Notice of Intent

Type of Action: APD Change

Procedure Description: OXY USA Inc. respectfully requests approval to amend the subject well AAPD wellhead design. See the attached diagram of the planning wellhead system for the Tails wells. The drilling rigs are currently moving onto the well pads to being drilling. OXY will use Cameron ADAPT wellhead system that uses an OEC top flange connection. This connection has been fully vetted and verified by API to Spec 6A and carries an API monogram. See the attached wellhead slide.

CAMERON ADAPT WELLHEAD - NM

OXY 13-5/8" 5K ADAPT NST
16" X 10-3/4" X 7-5/8" X 5-1/2"

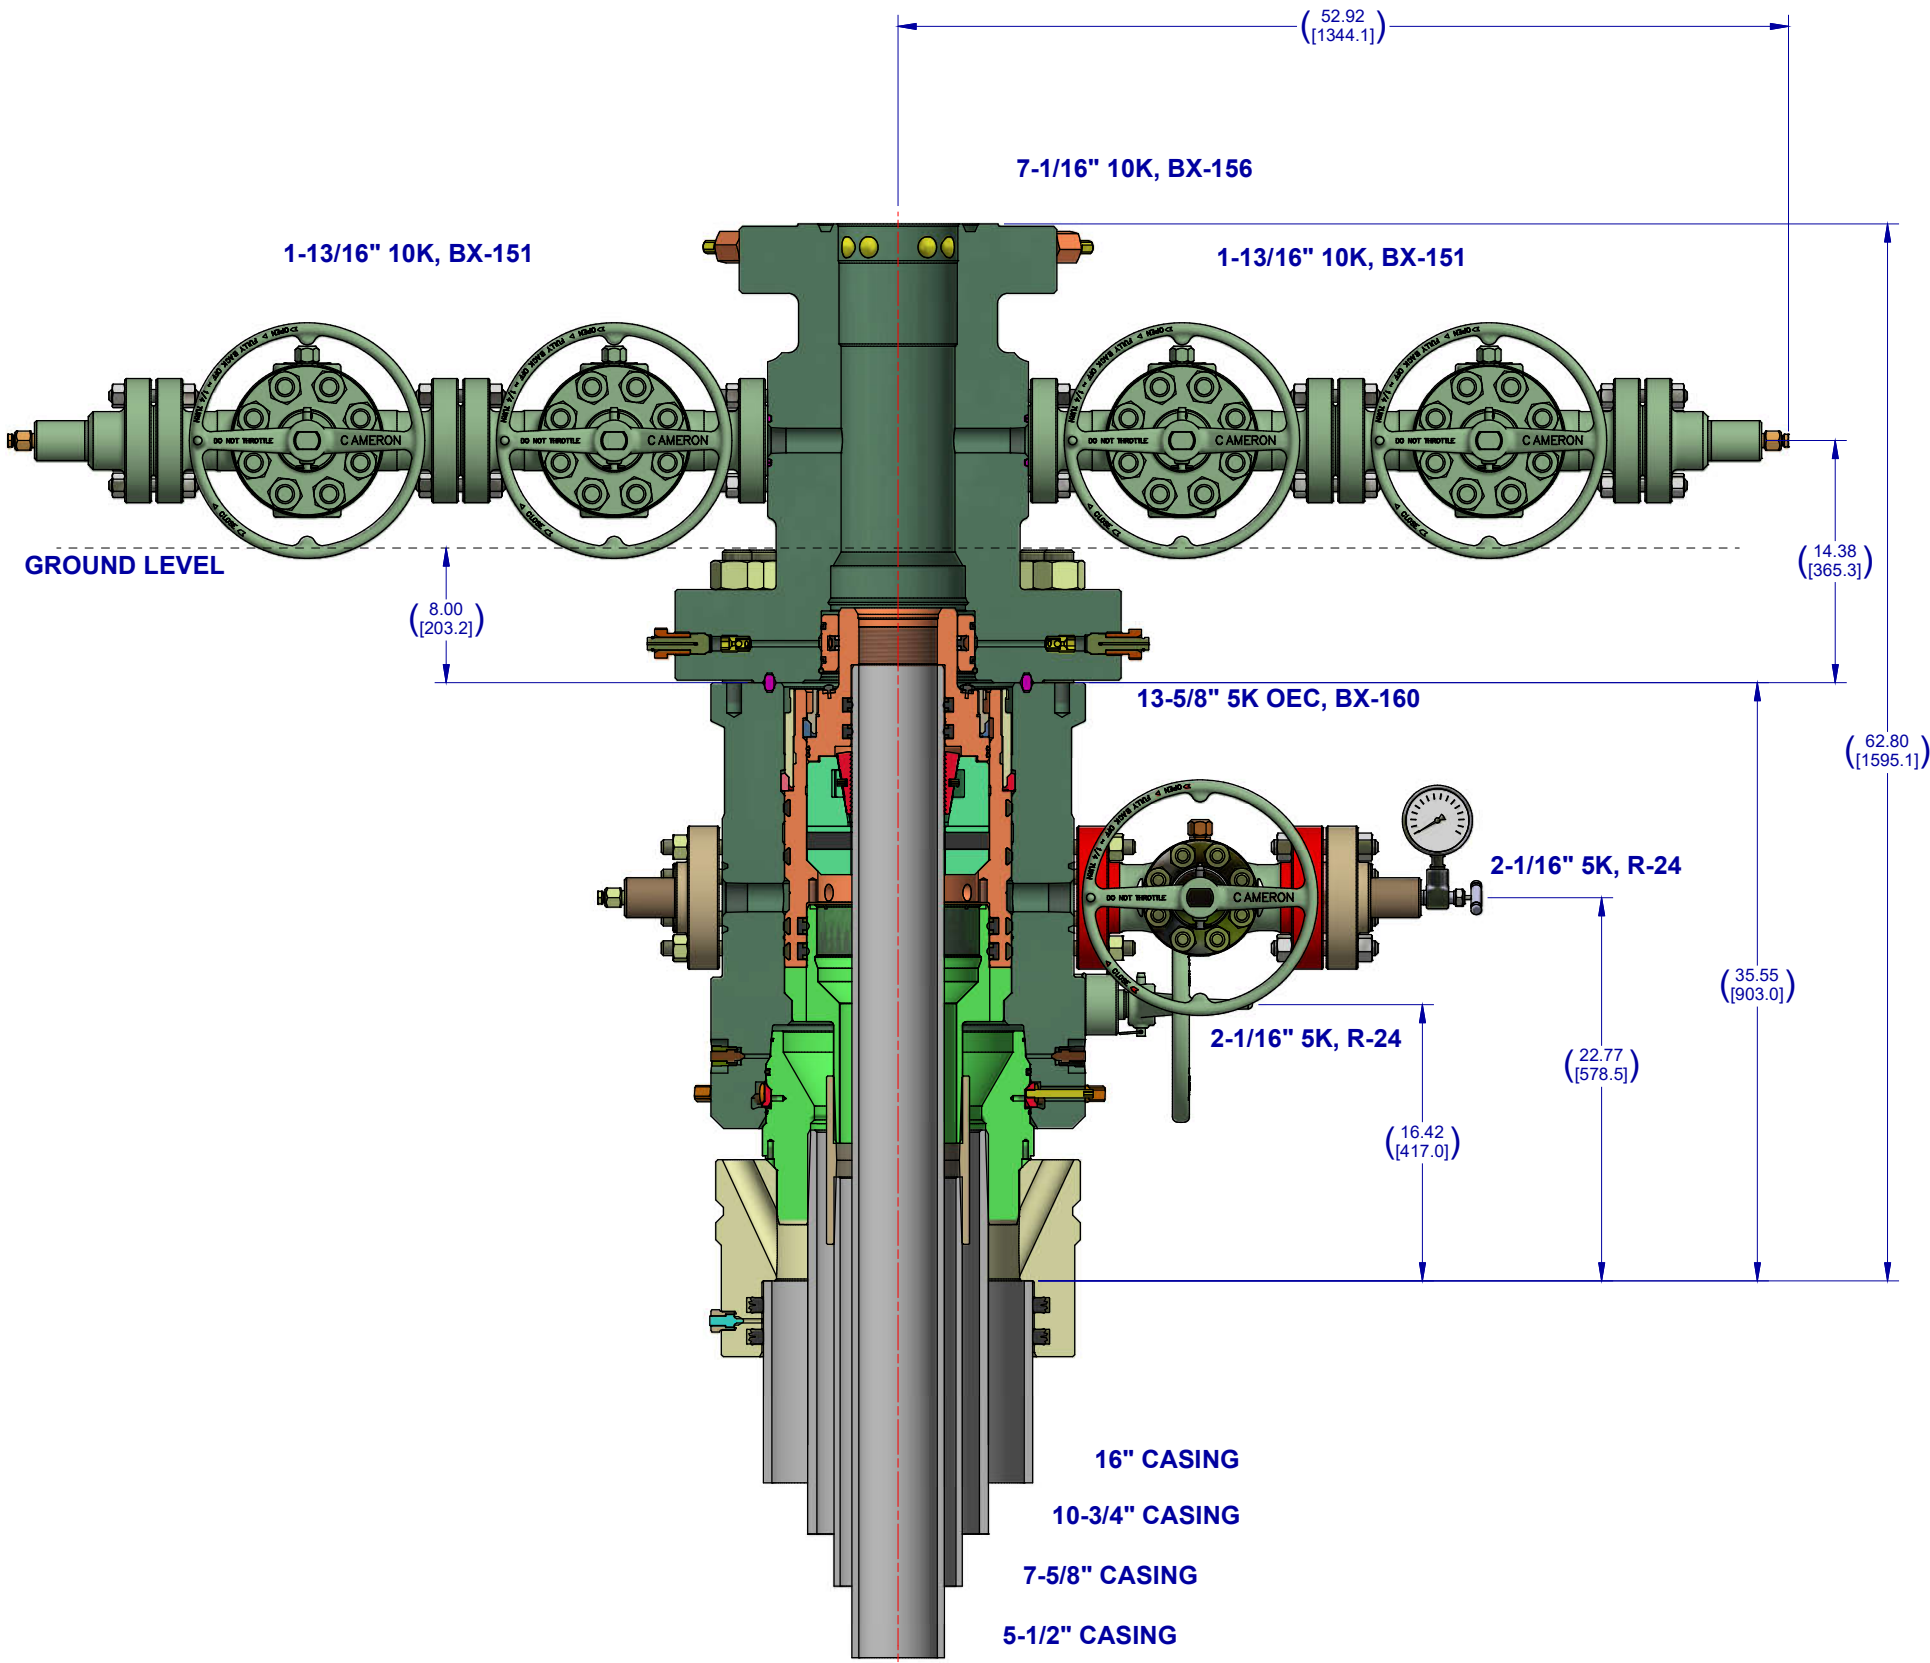
- All Wellhead Components have API monogram
 - Casing Bodies, Hangers, Tubing Spools, Valves, Slips, Ring Gaskets
 - Packoffs are not monogrammed per API
- Top connection of ADAPT casing head is not an API flange (classified as other end connector aka “OEC”),
 - Uses standard API ring gasket and has been certified and vetted by API
- R-type ring gaskets on casing head outlet valves
 - You could run RX if you wanted to
- BX-type ring gaskets for tubing spool + outlet valves
